LAND AT NORTH WEST BICESTER

TRANSPORT ASSESSMENT VOL 2 (ii) – APPENDIX E - J

STAGE 1 RSA DESIGNER'S RESPONSE

Stage 1 Road Safety Audit

Indicative staging and phasing

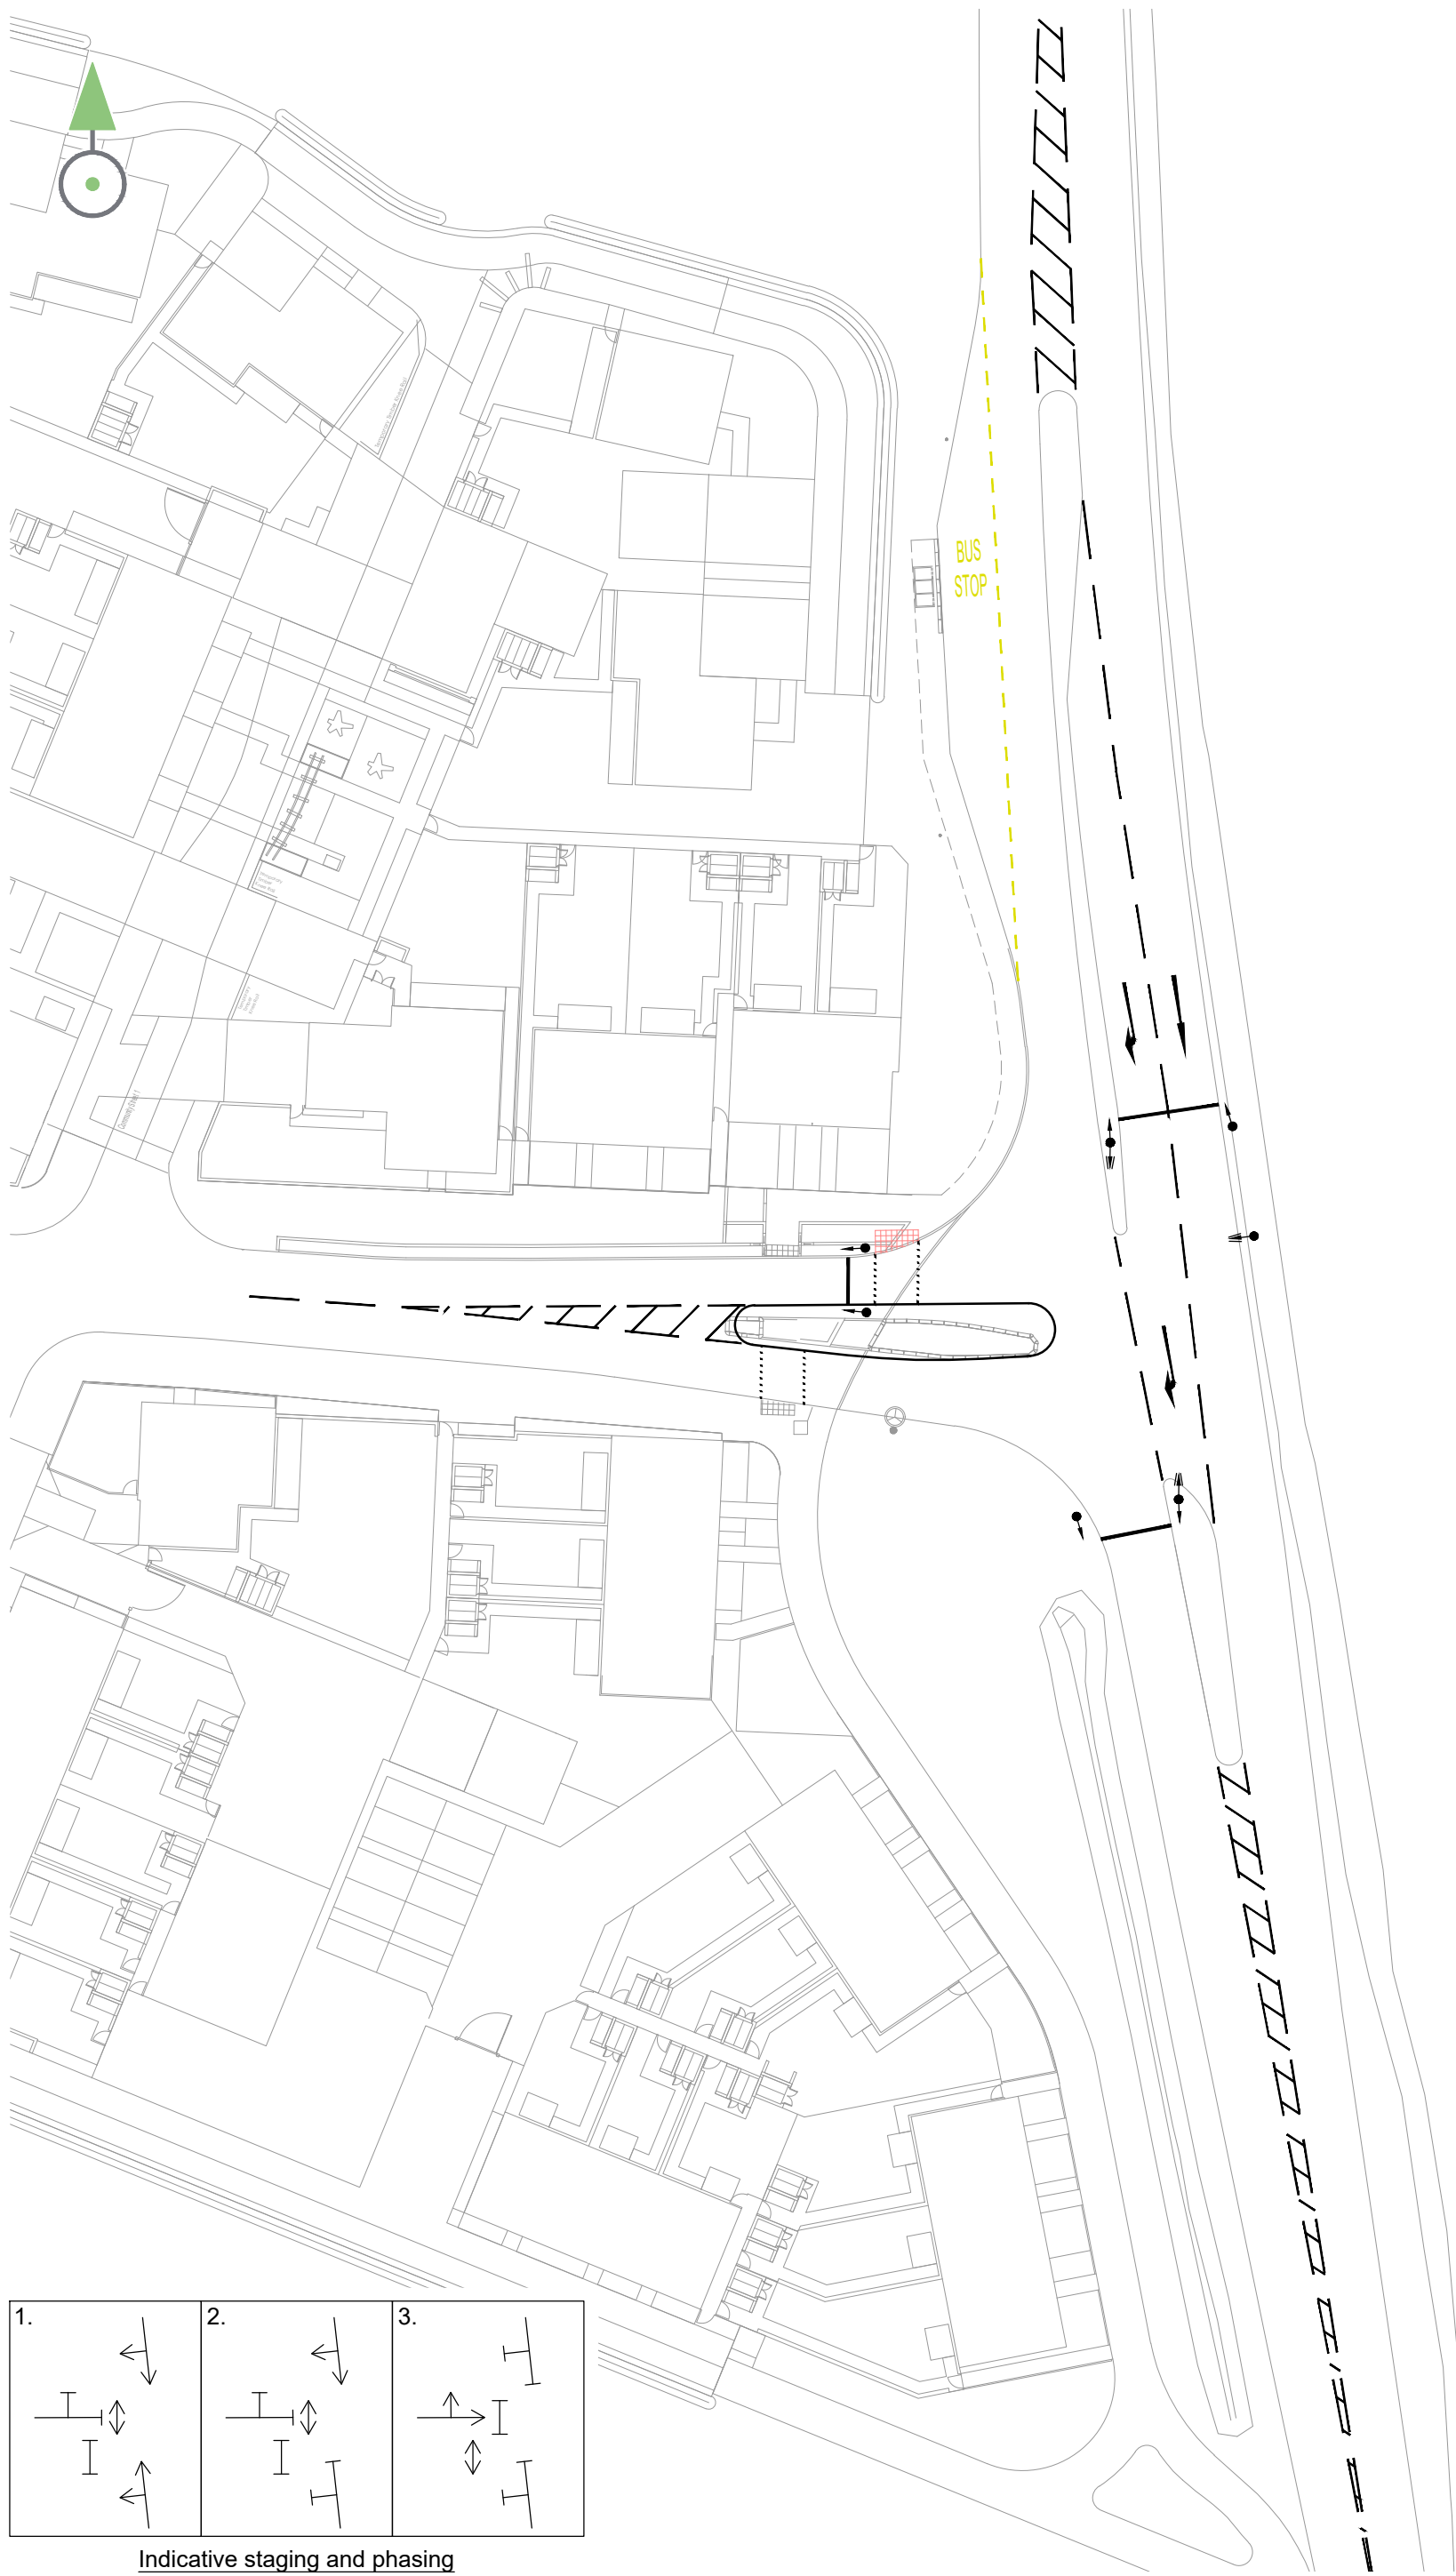
B	13.04.21	Staging diagram amended	MP
A	25.03.21	First issue	MP
REV	DATE	COMMENT	APP
REVISION DETAILS			
DRAWING NO.			
4600-1100-T-016			
DRAWN	APPROVED	DATE	
TC	MP	MAR 21	
SCALE			REV
1:500 @ A3			B
